**LANDMARK COMMISSION****April 6, 2026**

FILE NUMBER: COA-26-000113  
LOCATION: 4125 Junius St  
STRUCTURE: Contributing

A Courtesy Review of replacement of the exterior staircase on west side of existing carriage house with an addition, construction of a three (3) car carport directly behind main structure, and new steel frame screen fence and driveway gates.

6 PROPOSED GATES AND FENCE / NORTH ELEV  
Scale: 1/4" = 1'-0"

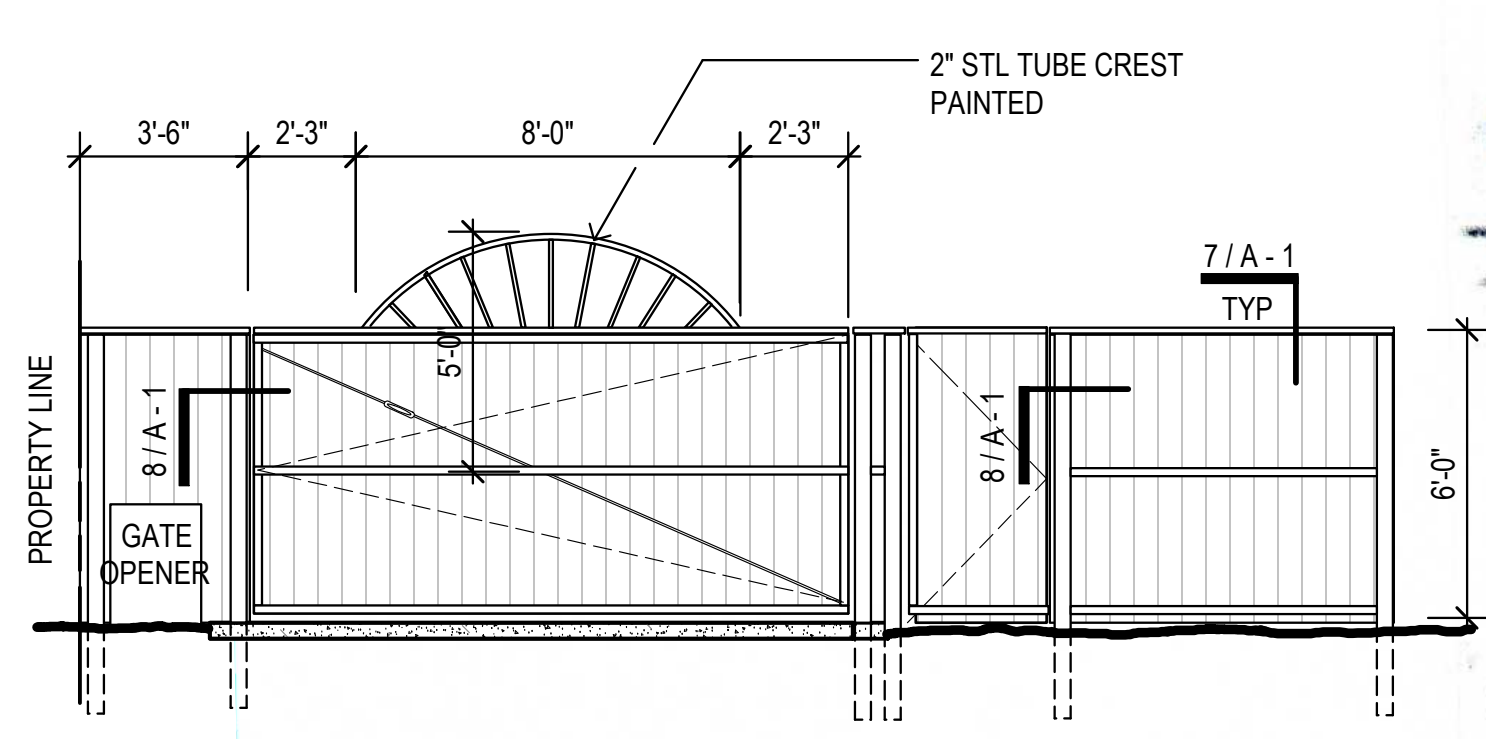
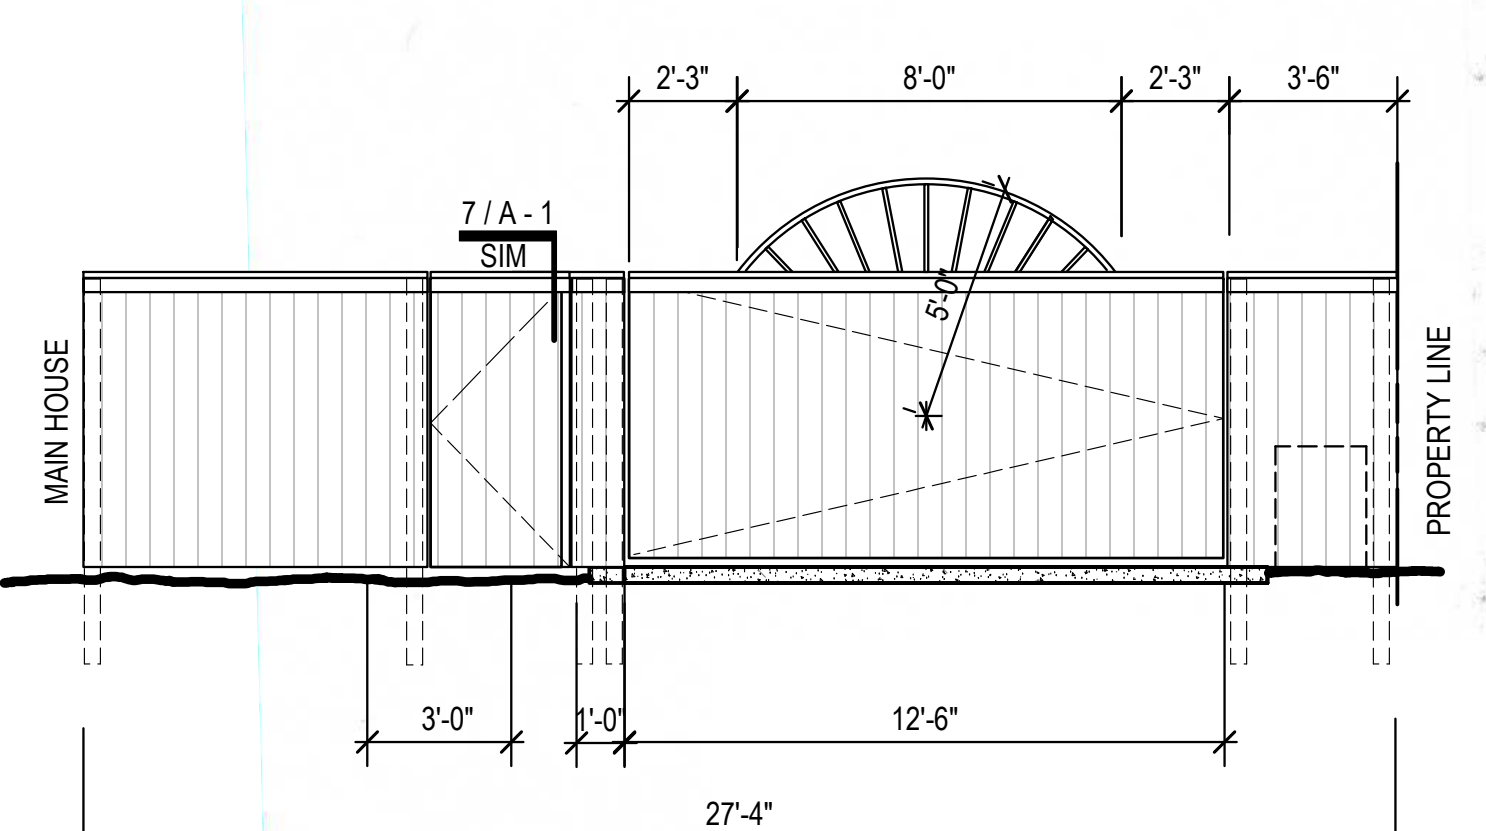
- Columns should be skinned to mimic pilasters on back of house (8"x8")
- Recommend a 12" beam across top (mimic frieze board)
- Need to know roof material/ color
- Fence must be at or behind the front 50% of the house
